PARTS SUPPLEMENT

New APC-7 Connector Coupling Nut

New and Old Coupling Nuts for APC-7 Connectors

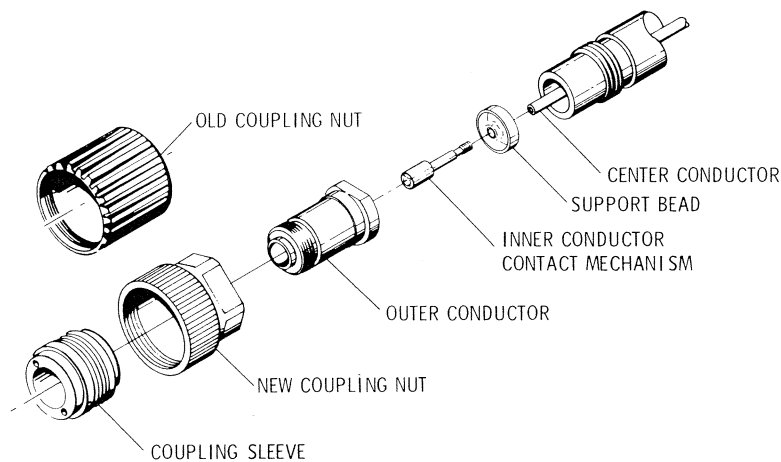
The new APC-7 coupling nut (HP Part Number 1250-1465) directly replaces the old APC-7 coupling nut (HP Part Number 1250-0819). The old and new coupling nuts are shown in the figure below.

The construction of the new coupling nut allows it to be torqued with a standard 3/4 inch open-end torque wrench for repeatable connections. The maximum torque to be applied to the coupling nut is 1.2 to 1.4 N·m (11 to 13 inch pounds). The new coupling nut mates with the old coupling nut. All other connector parts remain the same. Therefore, all performance characteristics are unchanged.
